North Dakota Department of Transportation

PLAN REVISION PROJECT NO. F-RRS-1-006(005)066

PLAN and/or CONTRACT REVISION

PROJECT NO.: F-RRS-1-006(005)066
 COUNTY: Morton
 CONTRACTOR: Northern Improvement
 DATE: January 18, 1991

TRAFFIC CONTROL SYSTEM
CONDUIT AND CONDUCTOR LAYOUT

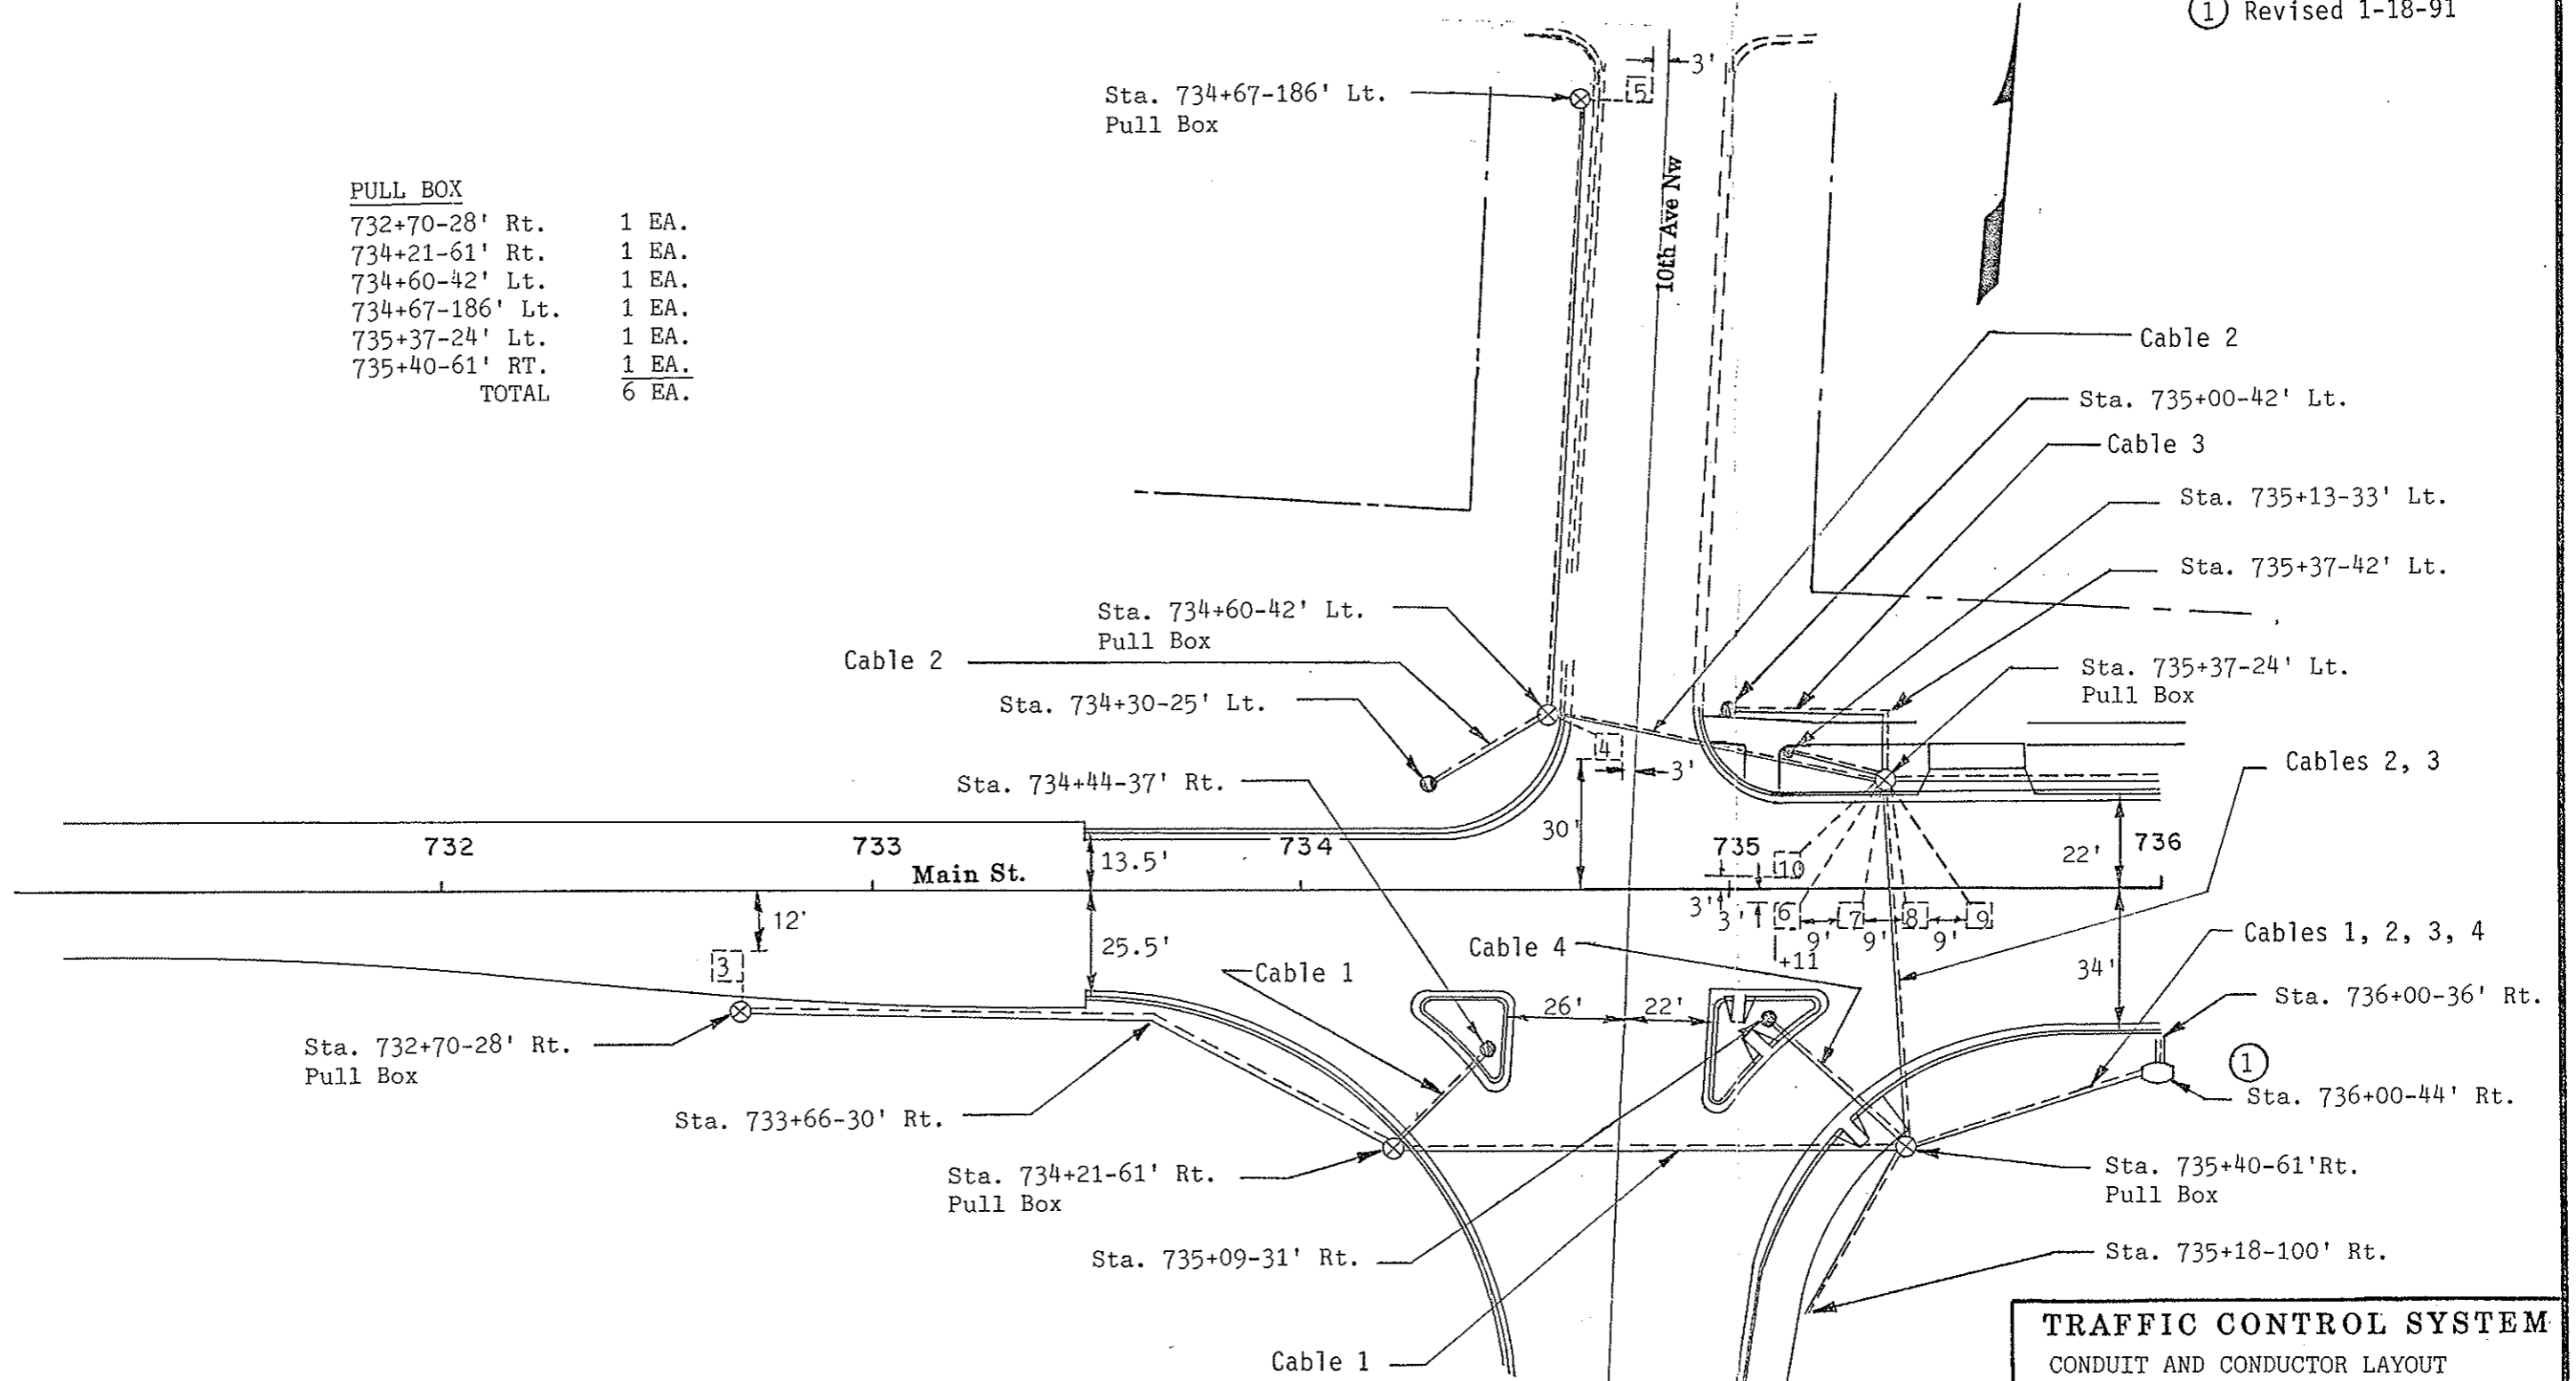
Sheet 85: Added 1" diameter conduit from station 736+00-36' Rt. to station 736+00-44' Rt.

Sheet 85: Added 1" diameter conduit from station 736+00-36' Rt. to station 736+00-44' Rt.

CONDUIT AND CONDUCTOR LAYOUT

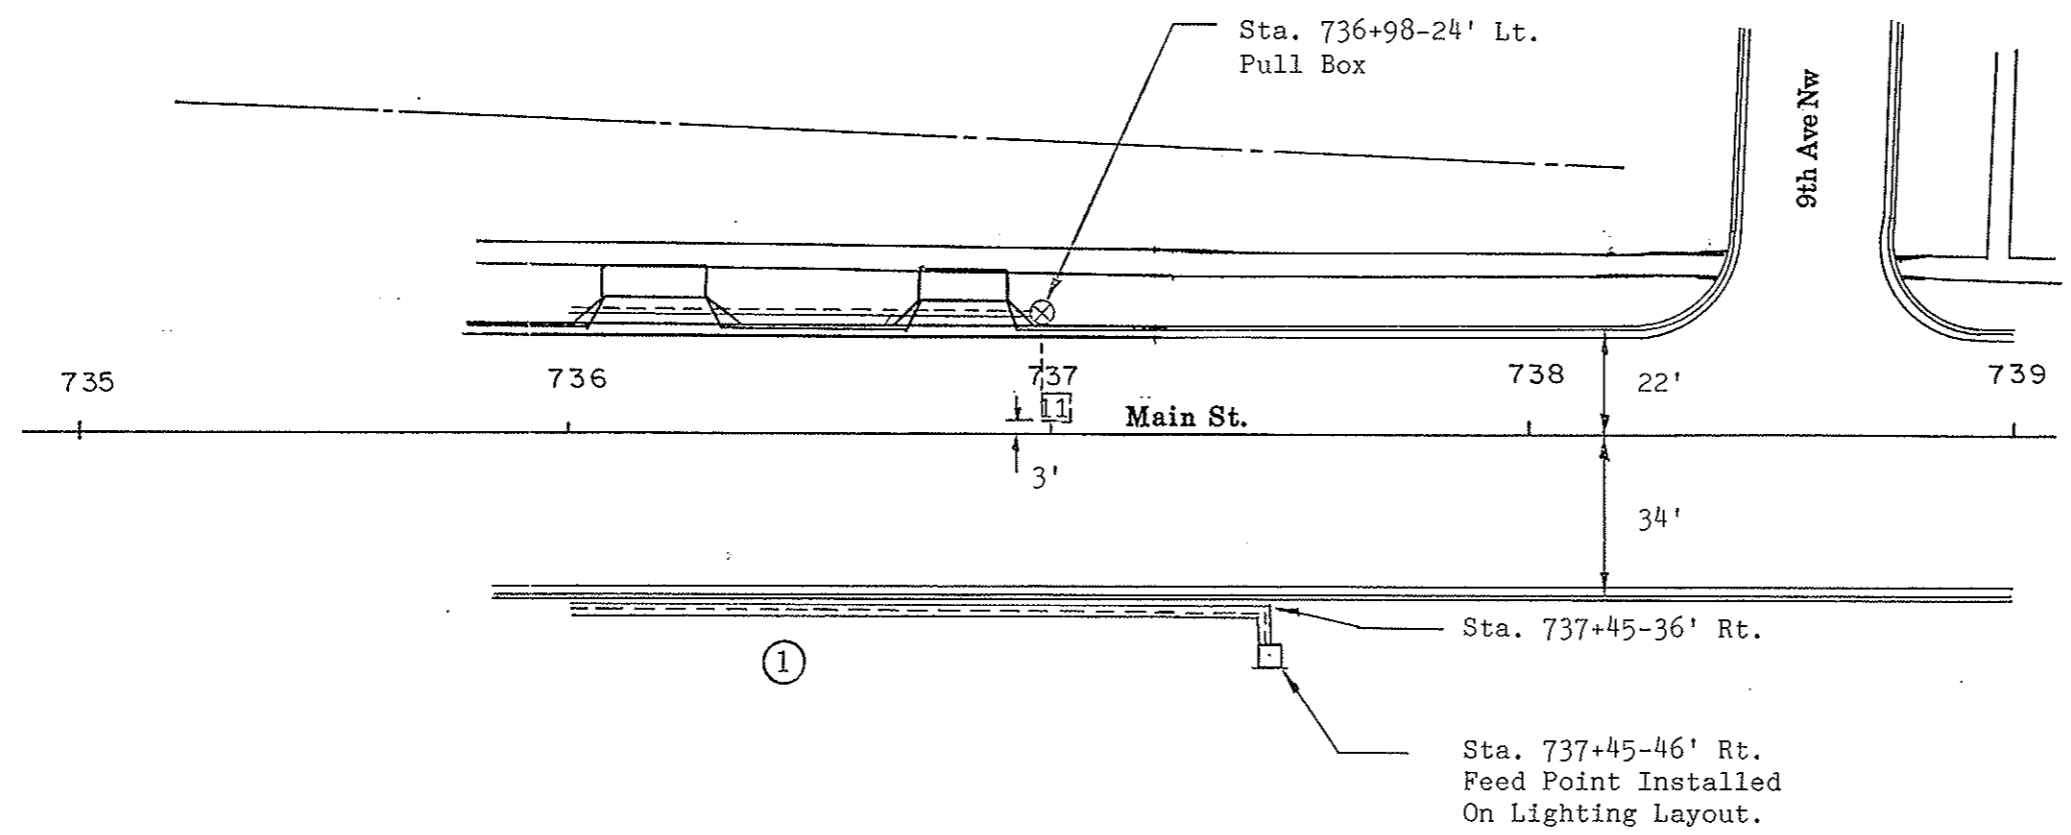
Sheet 86: Added 1" diameter conduit from station 735+00-36' Rt. to station 737+45-46' Rt.

Sheet 86: Added 1" diameter conduit from station 736+00-36' Rt. to station 737+45-46' Rt.

TRAFFIC CONTROL SYSTEM
 Lighting Layout
 Sta. 736+00 to 739+00
 Main St.
 10th Ave. sw (ND Hwy 6)
 Mandan N.D.

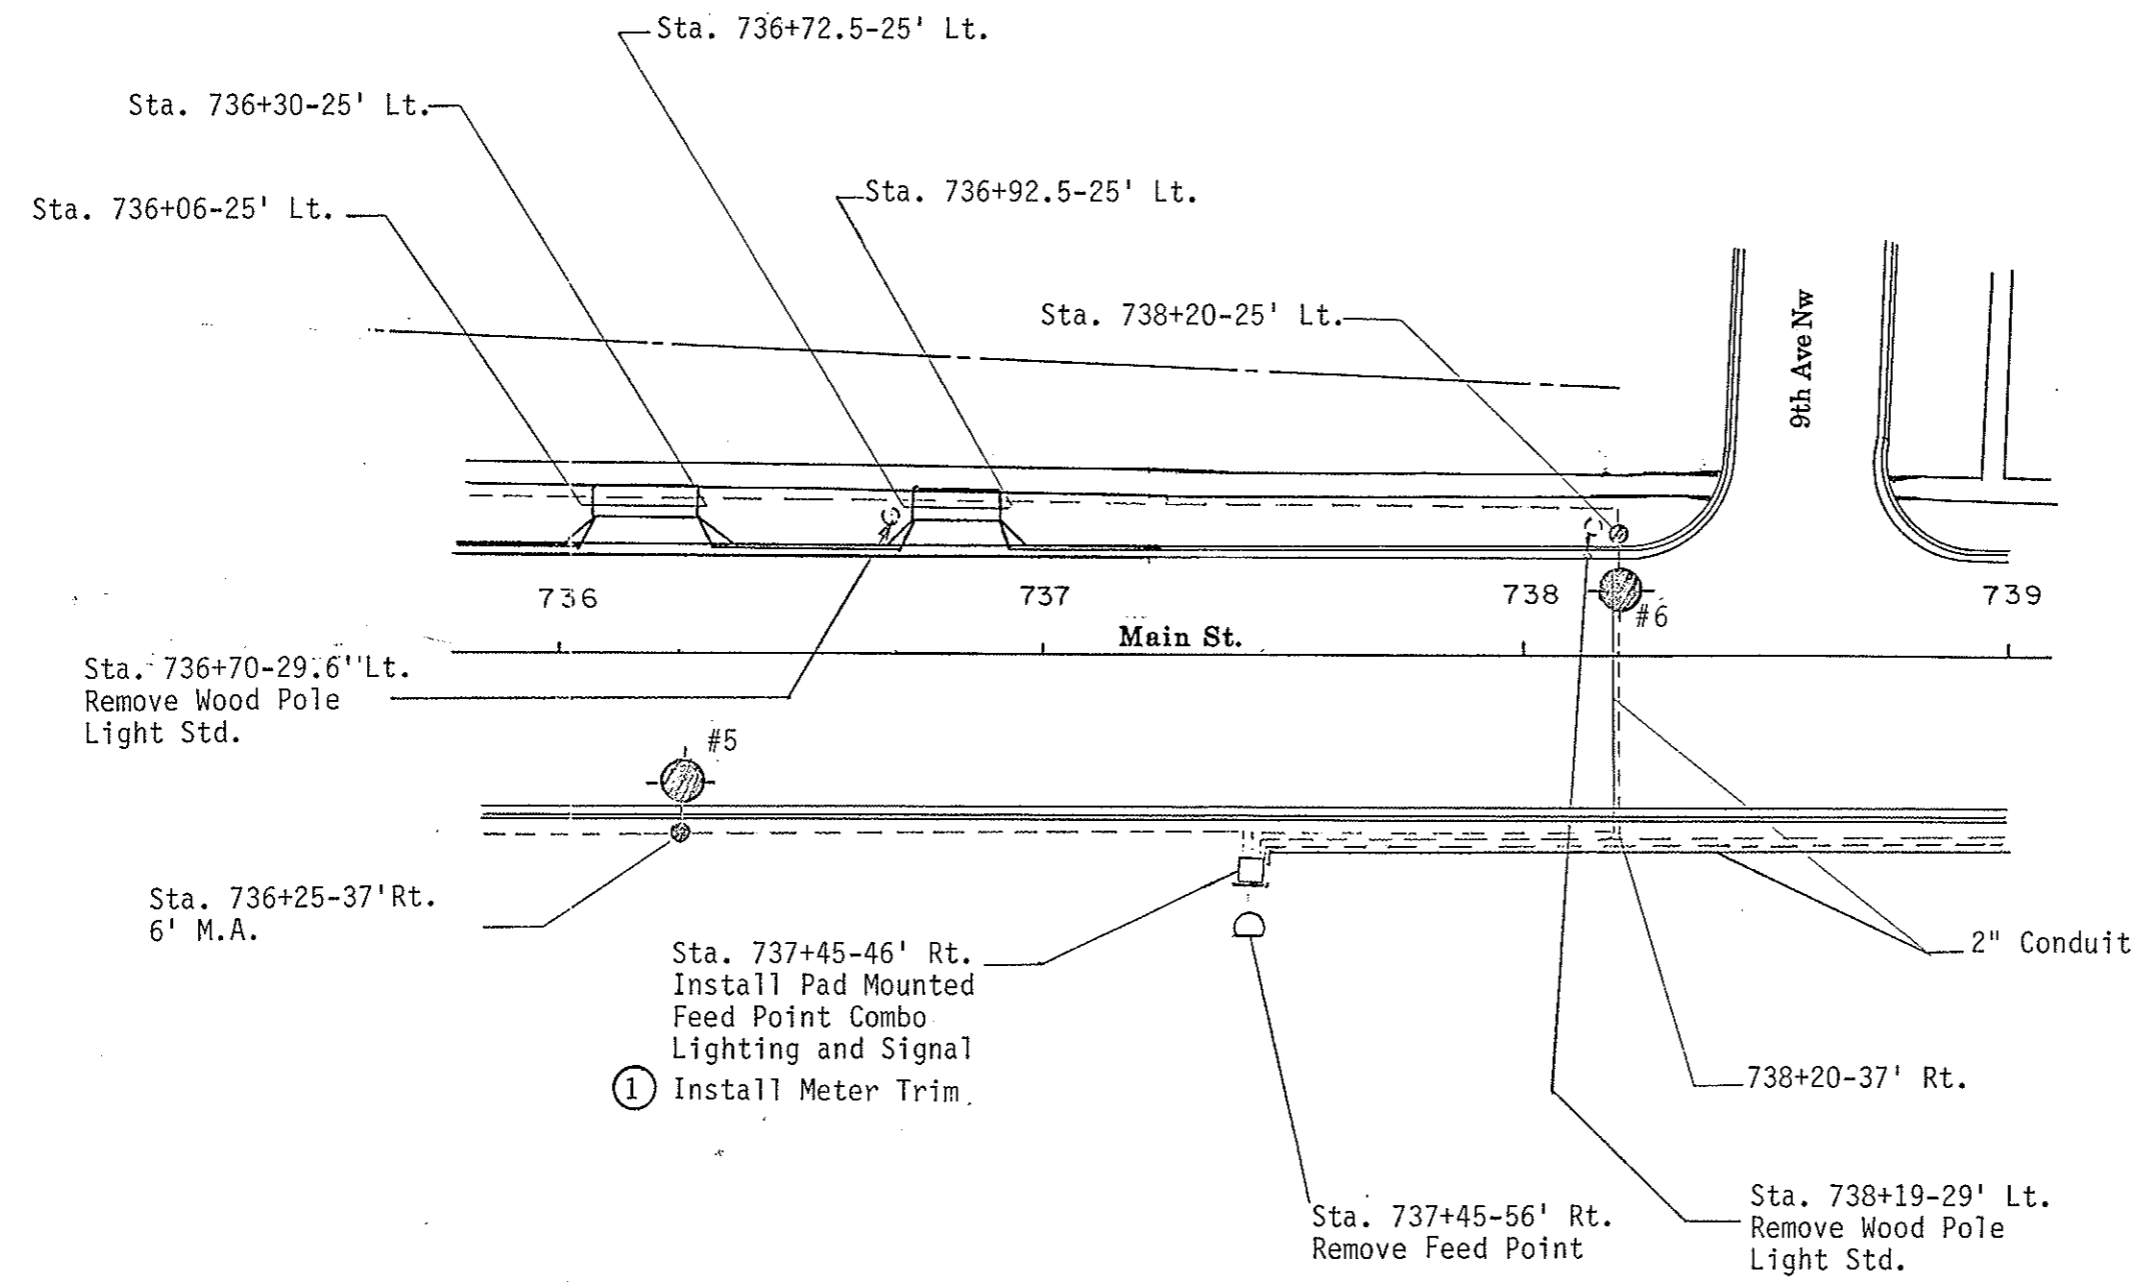
Sheet 103: Added meter trim to pad mounted cabinet.

Sheet 103: Added meter trim to pad mounted cabinet.

TRAFFIC CONTROL SYSTEM
 Lighting Layout
 739+00 to 11+00
 Main Av.
 10th Ave sw (ND Hwy 6)
 Mandan N.D.

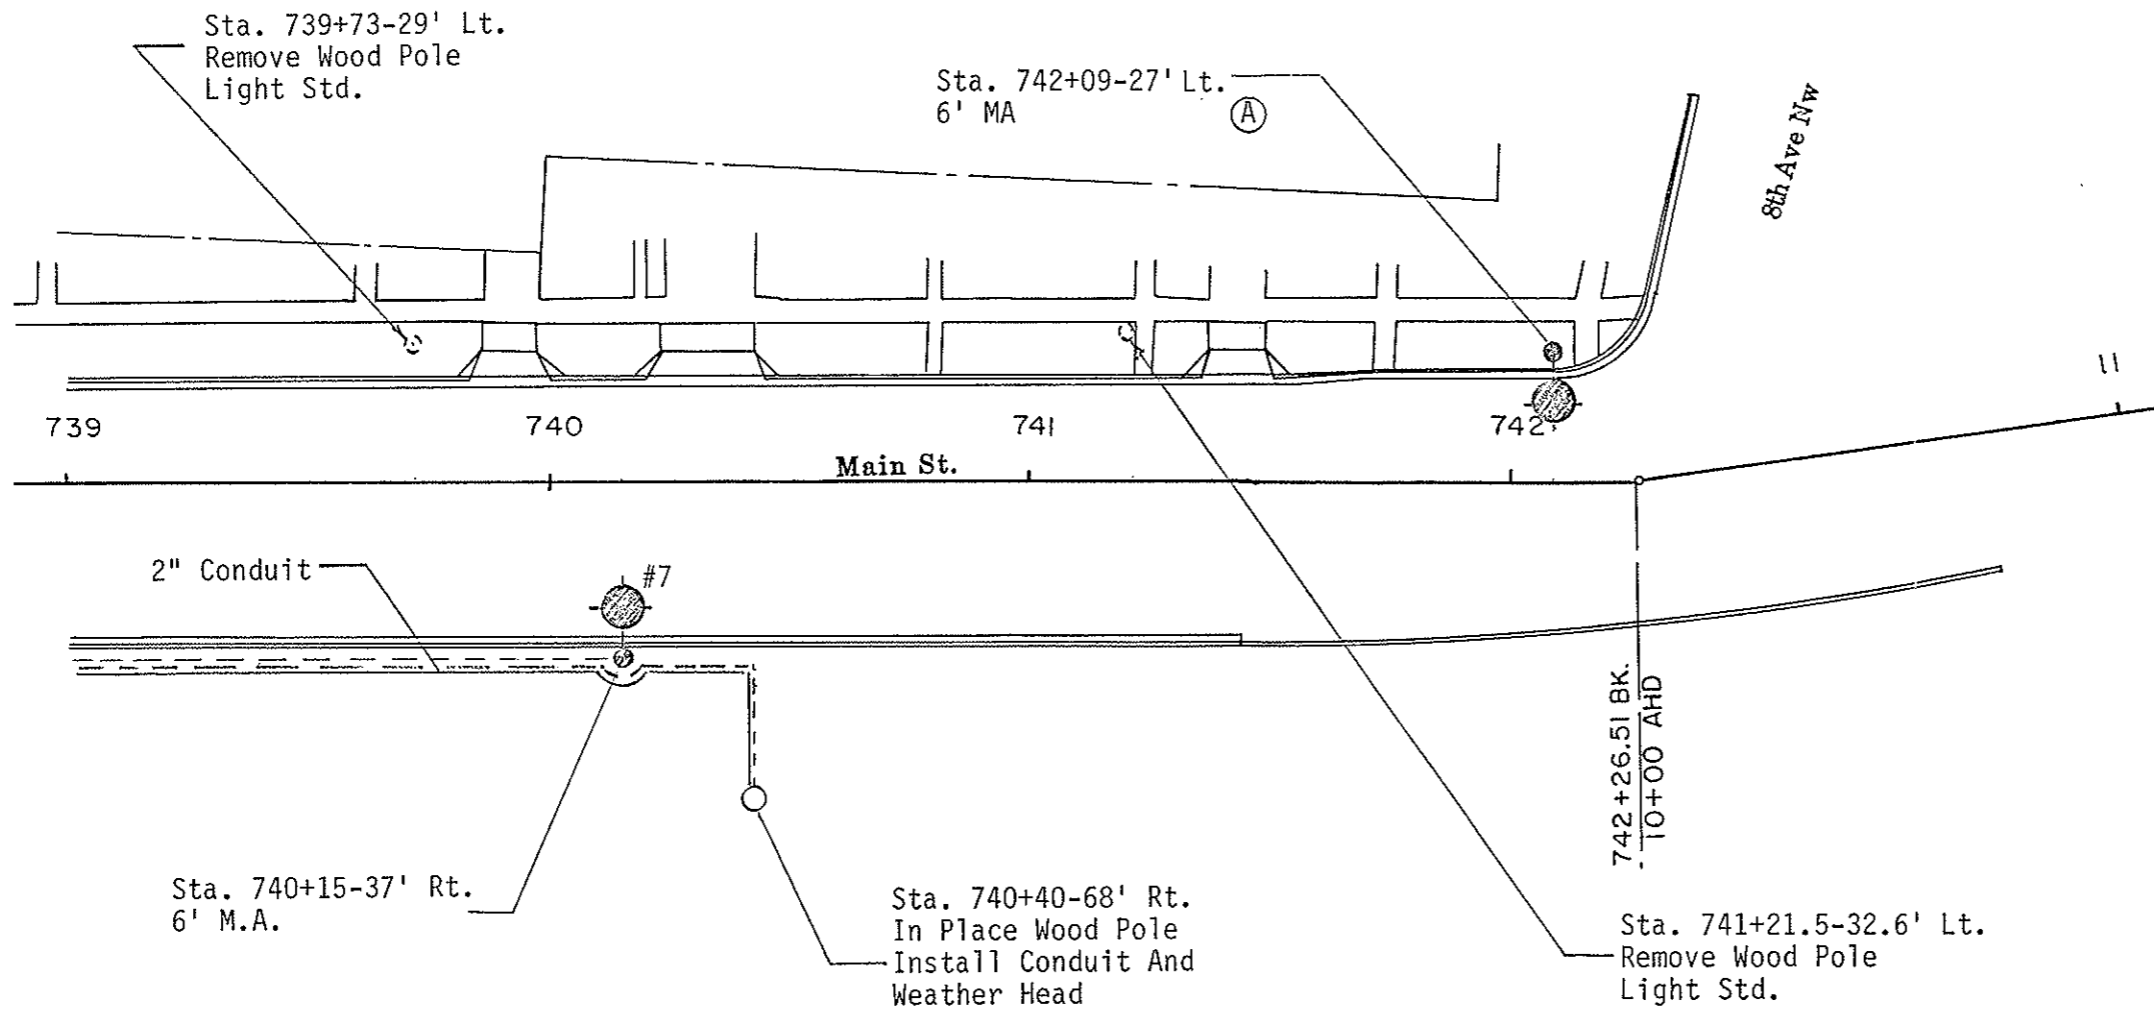
Sheet 105: Removed meter trim from wood pole at station 740+40-68' Rt.

Sheet 105: Removed meter trim from wood pole at station 740+40-68' Rt.

Ⓐ The contractor shall locate the existing conductor and salvage sufficient wire to make the connection to provide continuity
